**MOUNT POLLEY MINING CORPORATION
MOUNT POLLEY PROJECT
TAILINGS STORAGE FACILITY
AND ANCILLARY FEATURES**

**MAY 1, 1997 SITE INSPECTION
(REF. NO. 1627/4)**

SUBJECT: Site Inspection (May 1, 1997)

MOUNT POLLEY
SITE INSPECTION - MAY 1, 1997

Photo No. 10 - Reclaim Booster Pump station. Reclaim pipeline needs to be anchored where it exits the building. Note that overflow pipes from sump to T2 are not installed yet. Also, some repairs are needed to concrete inside T2 dropbox (patching).

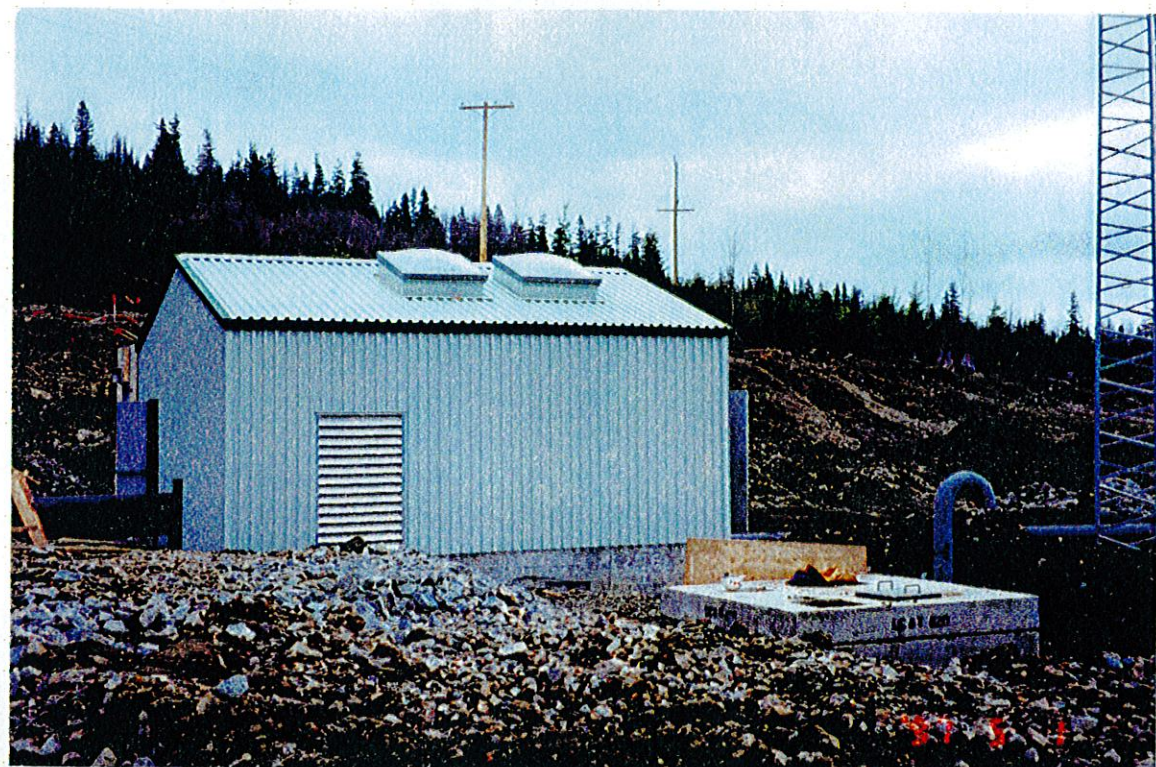
- (10) • An inverted block is recommended for the reclaim pipeline immediately up-gradient from the reclaim booster pump station. This is required to anchor the pipe in place, not just to prevent movement (like the regular anchor blocks do). If it is not possible to install this block because the pipe is in place, an alternative should be developed.

- (10) • The T2 drop box needs repairs to concrete.
- (10) • The overflow pipes from the reclaim booster sump to the T2 dropbox are not installed yet. MPMC to provide prefabricated pieces for NA because the pipes don't line up well. These pipes must be installed before any testing is started.

Photo No. 28 (Panorama No. 4) - View from Borrow Area (original) to Main Embankment. Note movable discharge section being assembled at the right abutment.

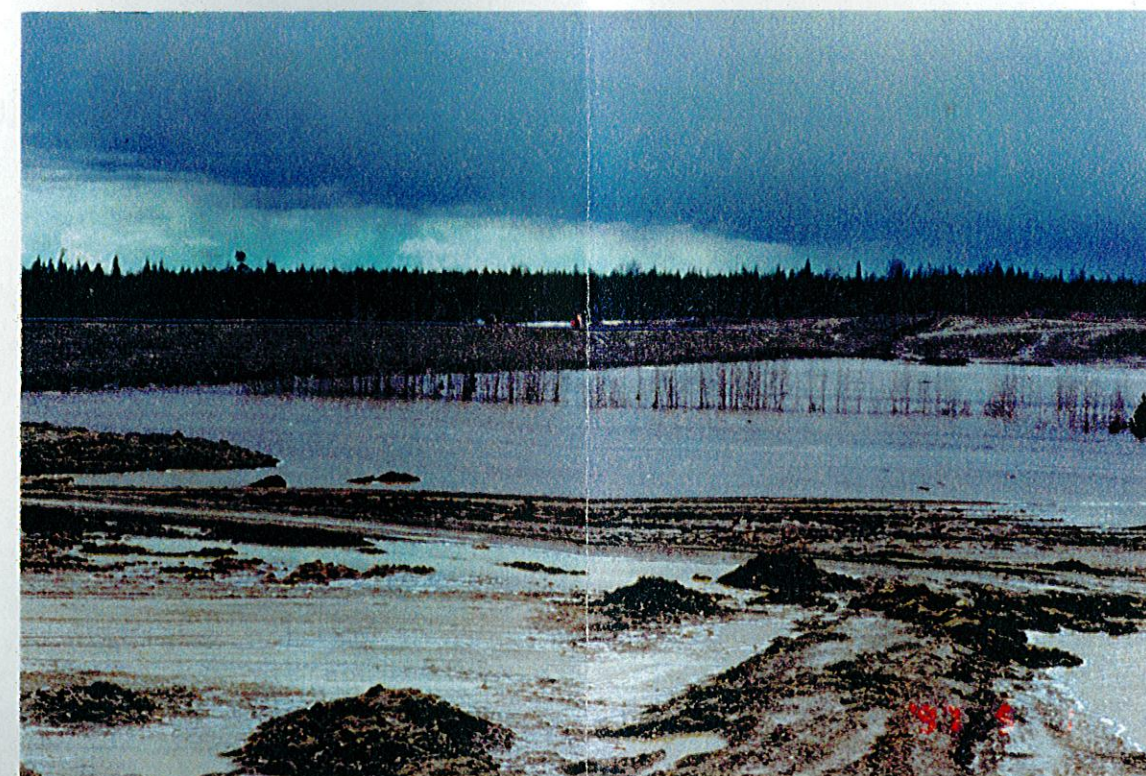
- (27) • The movable discharge section is set up at the right abutment (Ch. 16+00 to 19+00). It should be moved to the deepest part of the basin (Ch 19+50 to 21+50) as soon as a beach develops at the right abutment.

Photo No. 34 (Panorama No. 5)

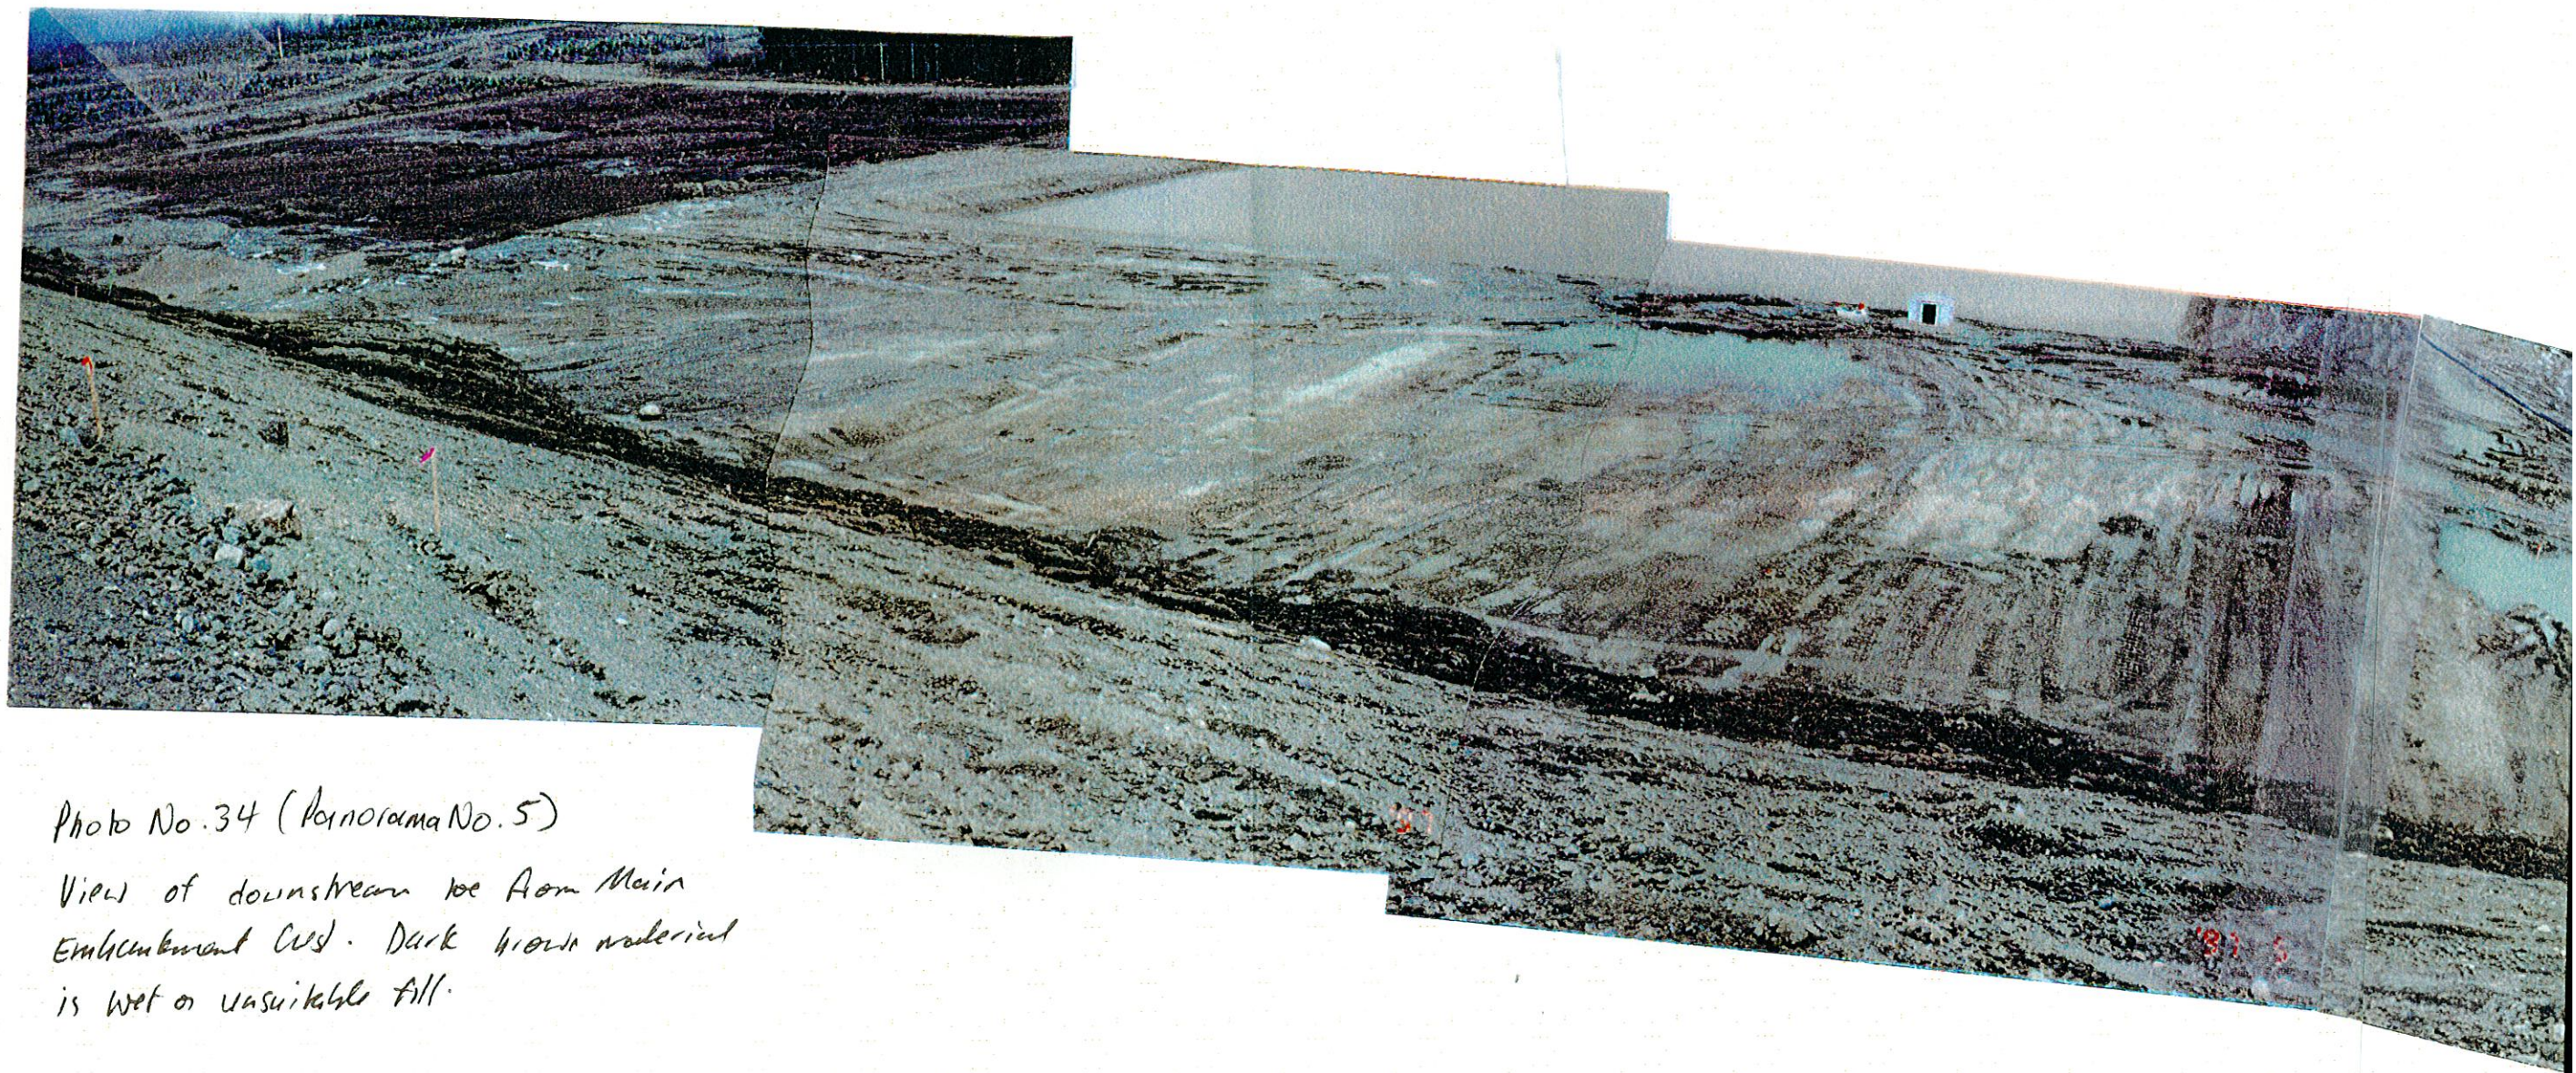
- (25, 30, 31, 32, 33, 34) • The pile of wet "unsuitable" fill included snow and ice from clearing of the Stage 1a El. 920 Zone B crest. The result is that the overbuilt area is unstable, with loose fill and cracking evident. Moisture is being absorbed by drier fill above the "unsuitable" fill piles, resulting in more slumping and cracking. Some cracks may be as high as El. 918 m. This "unsuitable" fill is continuous below the Stage 1a crest and slumping and cracking are especially obvious where the "unsuitable" fill piles are larger. There are occasional seeps coming out of the melting unsuitable fill piles. These seeps are believed to be the result of melting snow and ice in the "unsuitable" fill piles. All "unsuitable" material should be removed and the downstream slope redressed over the area as described above.
